Subject: Submittal of Final Record of Decisions for the Abandoned Deactivation Furnace (SEAD-16) and the Active Deactivation Furnace (SEAD-17); Contract DACA87-95-D-0031, Task Order 03 Seneca Army Depot Activity; File No. 1017A

**Subject: Submittal of Final Record of Decision for the Abandoned Deactivation Furnace
 (SEAD-16) and the Active Deactivation Furnace (SEAD-17);
 Seneca Army Depot Activity; NYS ID#8-50-006; CERCLIS ID# NY0213820830**

RESPONSE TO COMMENTS

Army's Response to Comments from the US Environmental Protection Agency

**FIGURE 1-2
 SEAD-17 REMEDIATION AREA**

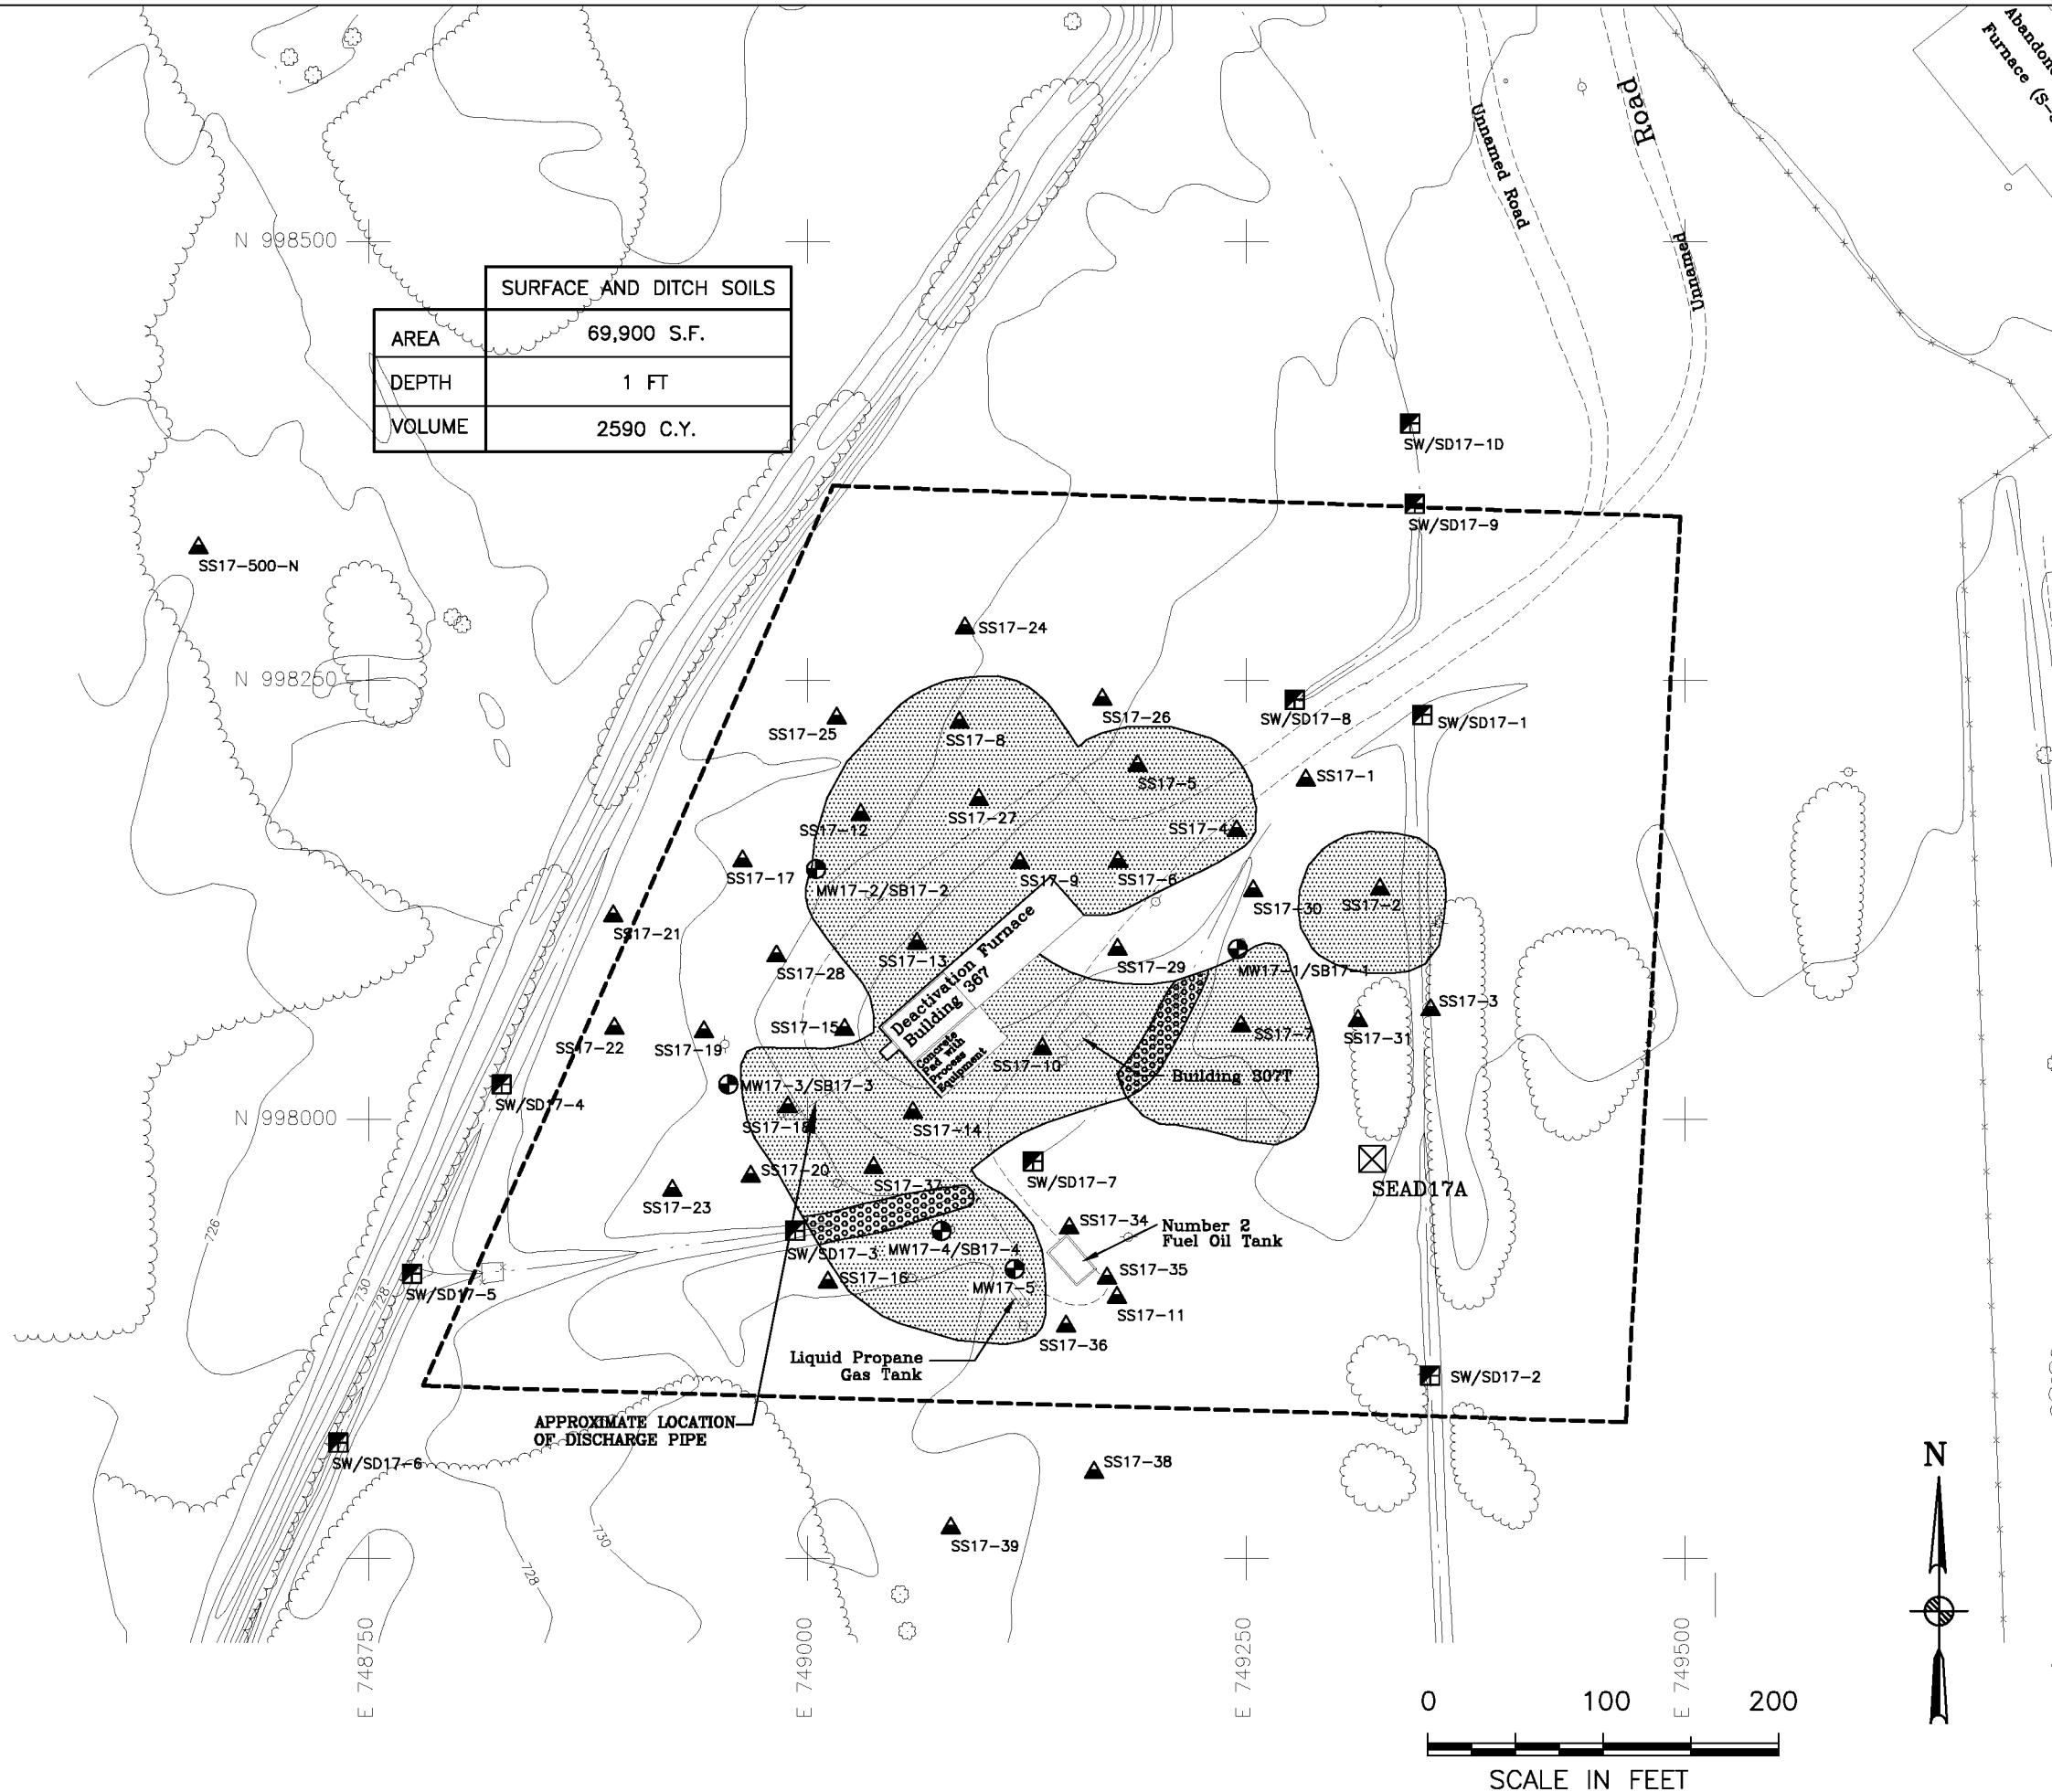
Comment 6: Figure 1-2: Institutional Controls for SEAD-17 require that the site be completely bound. Please establish the north and south boundaries, and revise the map accordingly.

Response 6: The proposed remedy includes additional sampling as part of the pre-design sampling program to further delineate the area of excavation. The pre-design sampling will also serve to define the boundaries of SEAD-17 and the boundaries upon which institutional controls will be required.
